Sydenham to Bankstown Metro

Submission on Preferred Infrastructure Report

Endorsed by Council 24 July 2018

Figure 10. The project does not make any reference to the *Future Transport Strategy 2056* vision above, which extends north south and west from Bankstown.

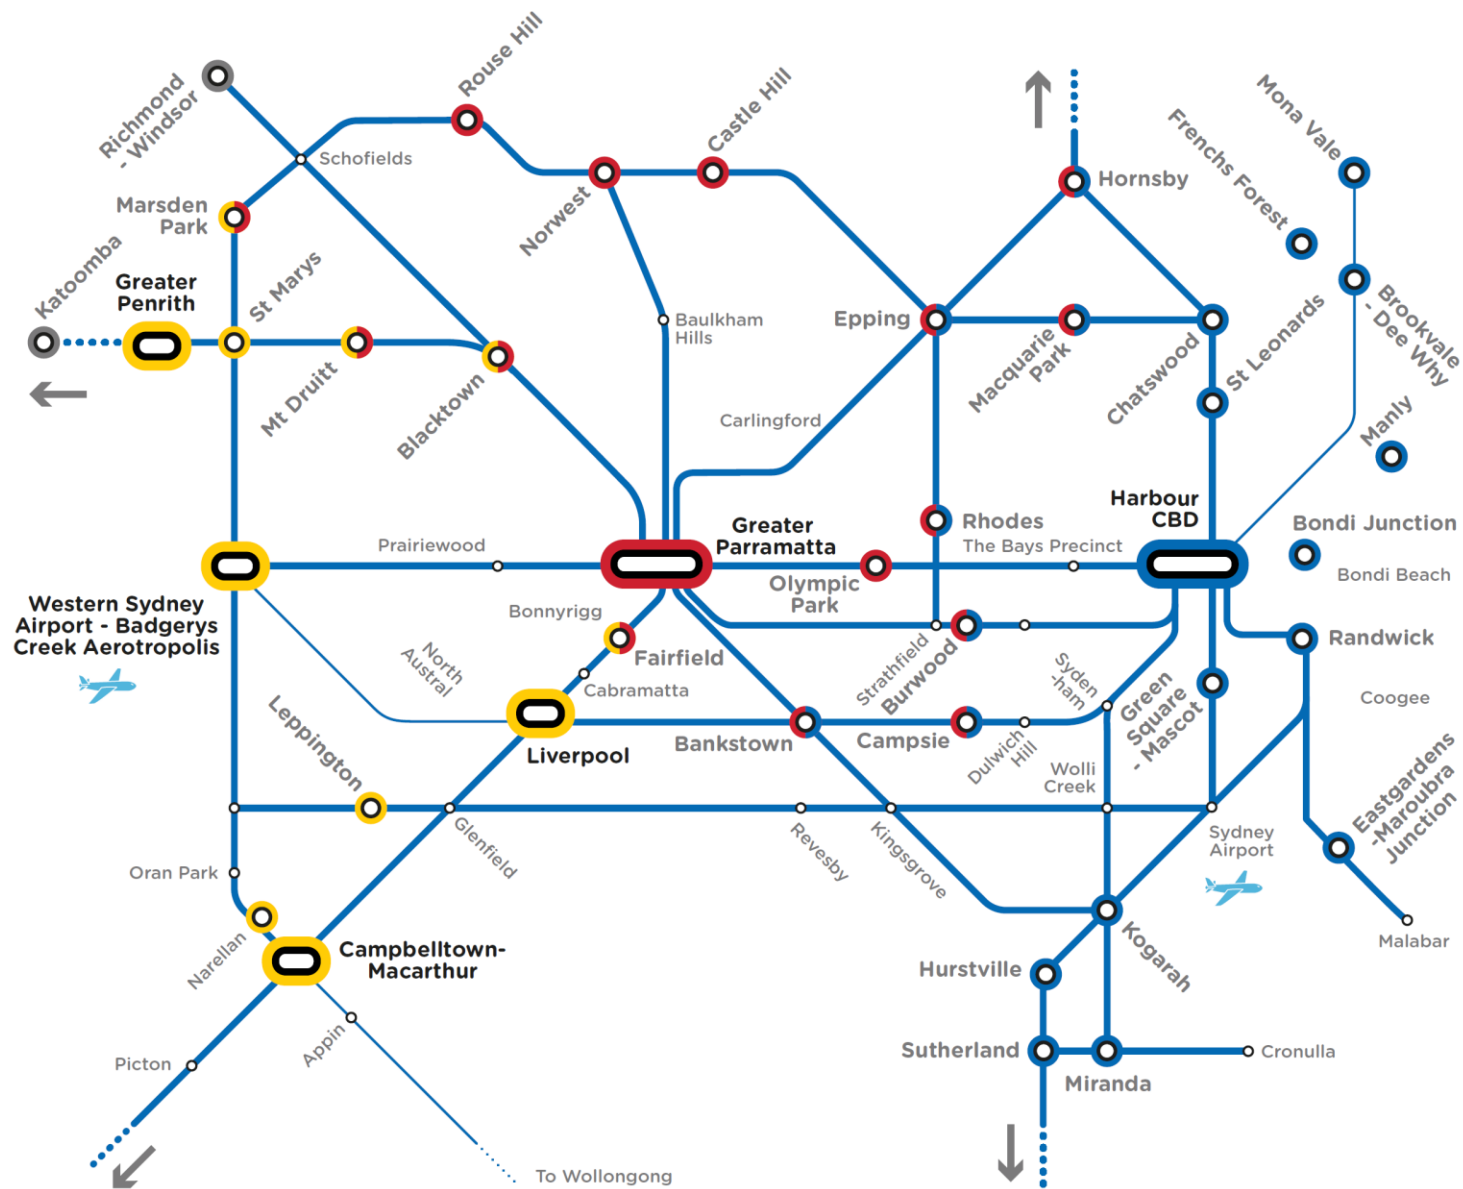
The PIR also fails to address how the Metro will adequately integrate with the 2056 vision for high frequency services from Bankstown to Liverpool, Parramatta and Kogarah (refer Figure 10). The PIR simply shows an indicative box next to Bankstown Station where an underground station could be built (although it appears too small for this) without any reference to constructability and impact minimisation
